RS-10-174
October 14, 2010

LaSalle County Station, Units 1 and 2
Facility Operating License Nos. NPF-11 and NPF-18
NRC Docket Nos. 50-373 and 50-374

Subject: Supplemental Information Concerning License Amendment to Allow Receipt and Storage of Low-Level Radioactive Waste at LaSalle County Station, Units 1 and 2

Response to Requests for Additional Information Concerning License Amendment to Allow Receipt and Storage of Low-Level Radioactive Waste at LaSalle County Station, Units 1 and 2 Facility Operating Licenses NPF-11 and NPF-18

Figure 1: LSCS Site Boundary and Owner Controlled Area

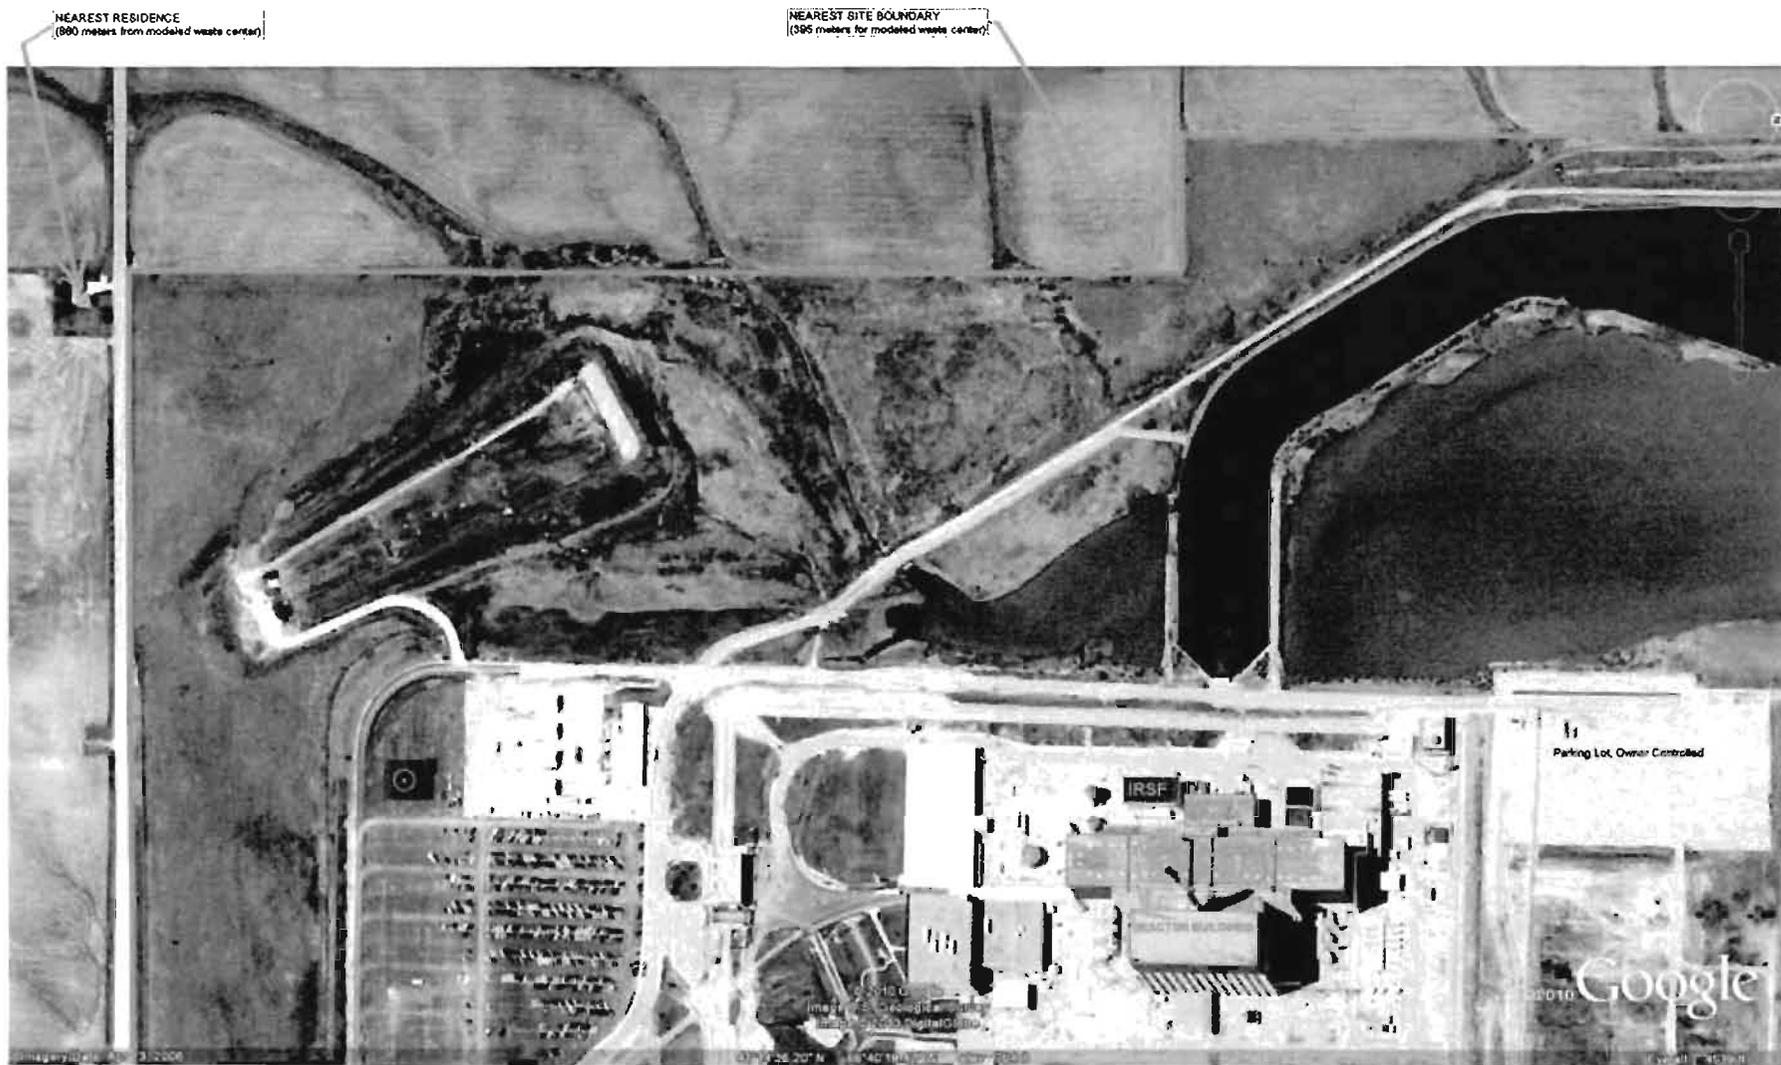
"For onsite radiation protection purposes, describe the boundaries of the Title 10 of the Code of Federal Regulations Part 20 (10 CFR 20) controlled area (e.g., provide map and distances to the LLRW Storage Facility); describe whether members of the public are allowed in the controlled area, and describe how the dose limits of 10 CFR 20.1301(a) and (b) will be met."

The LSCS IRSF is located inside the station protected area, as well as the site boundary and exclusion area boundary, as depicted on Figure 1, "LSCS Site Boundary and Owner Controlled Area," and Figure 2, "LSCS Site Boundary/Owner Controlled Area, Nearest Resident, IRSF in Relation to Other Plant Structures."
